# Pedestrian Safety and Accessibility

## For members of Ohev Sholom National Synagogue

## Issue 7

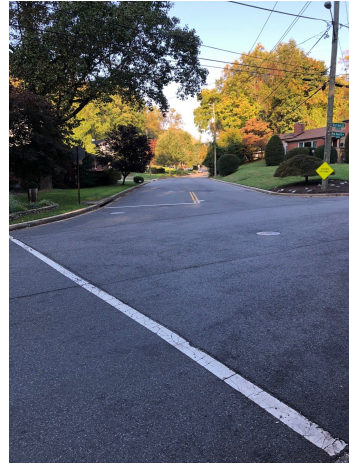
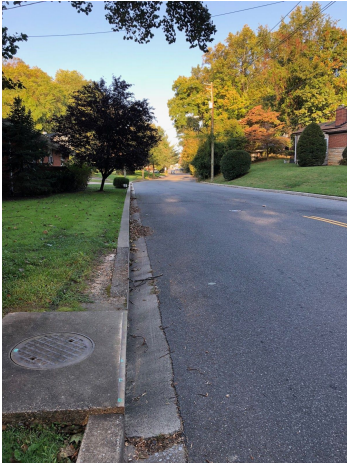
The sidewalk on the east side of West Beach Dr. NW, across from the residence of 8114 West Beach Dr. NW, has a lip between the sidewalk pavement and the stormwater catch basin, making wheelchair and stroller access difficult. We recommend that the pavement be repaired to offer a smooth transition.
